# BLYTHE MESA SOLAR PROJECT

## Final Environmental Impact Report/Environmental Assessment

### Volume V: Technical Appendices

### RESPONSE TO COMMENTS

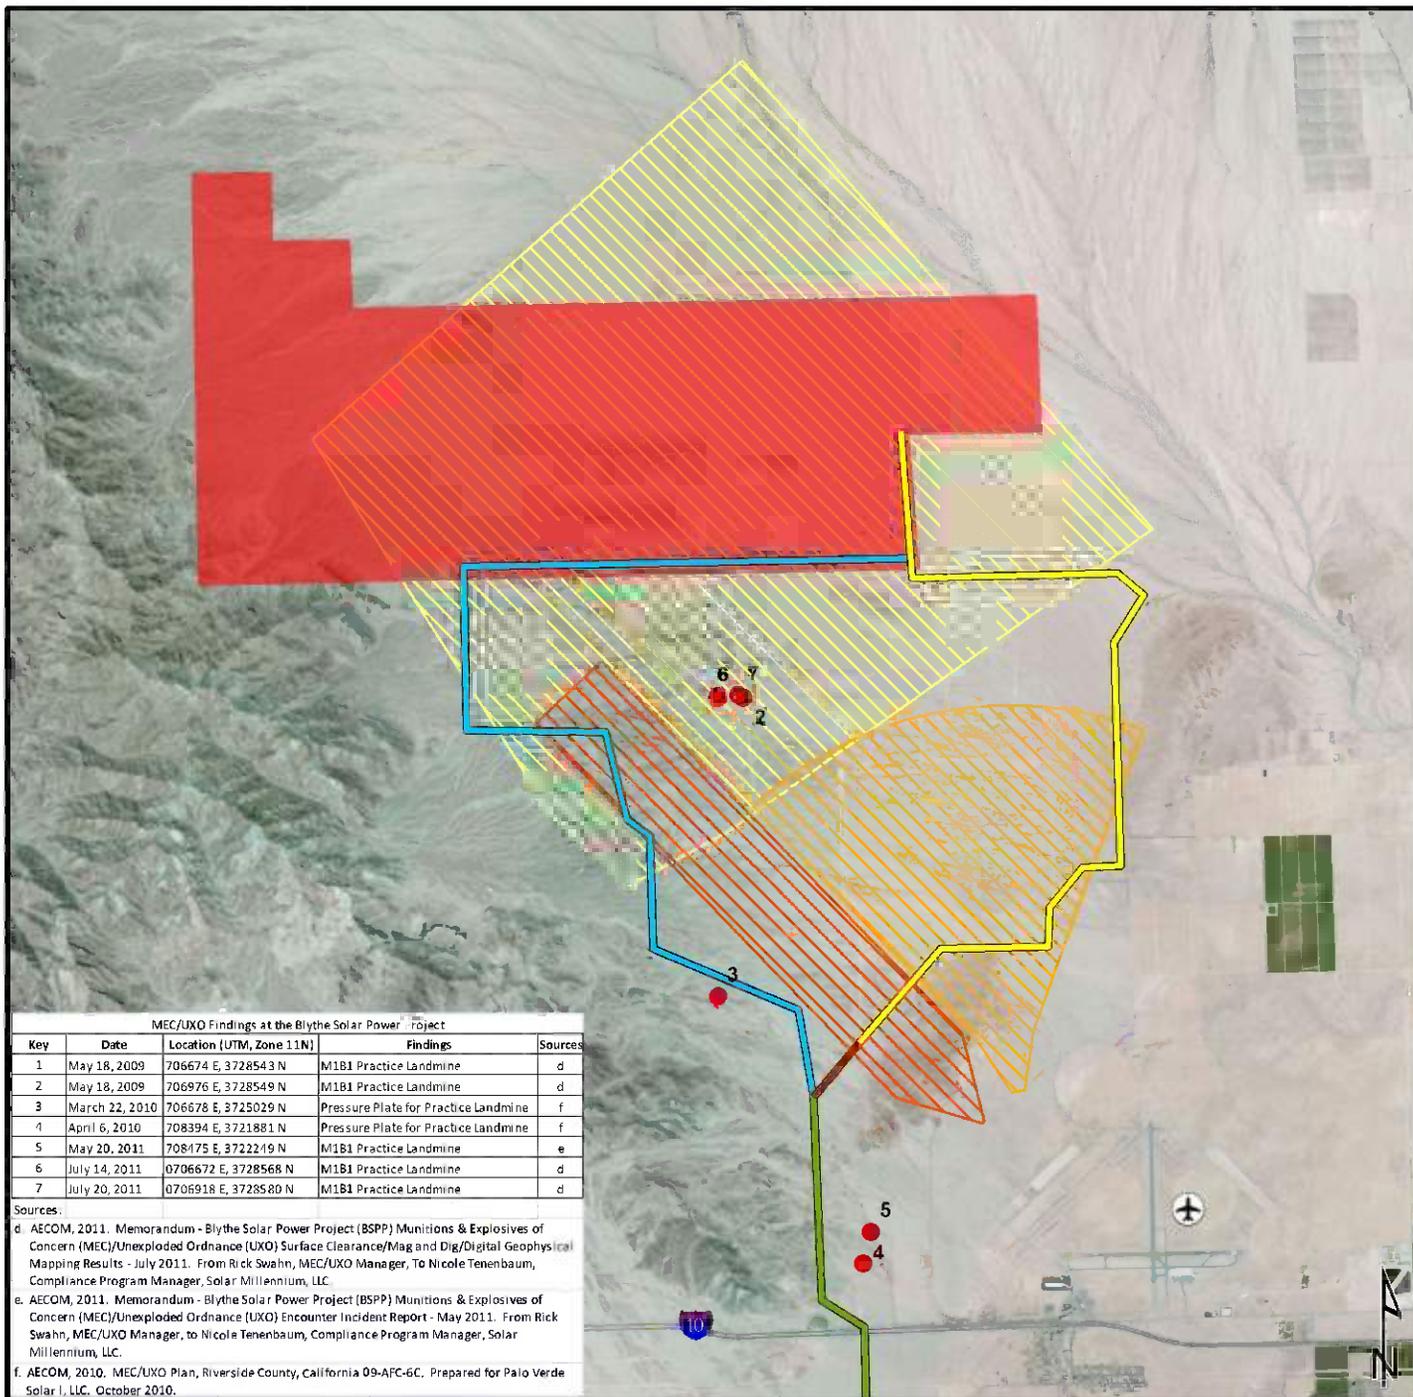
UXO has been documented in association with the neighboring Blythe Solar Power Project (BSPP), located within less than 500 feet south of the Project site. During construction of the BSPP, seven separate UXO-related material findings have been reported. These incidents are documented in Monthly Compliance Reports and associated attachments, which were prepared by the applicant and submitted to the California Energy Commission. We obtained these reports and have created a map to show where UXO have been found (Figure 2, Attachment B). These findings are also described in the table below.
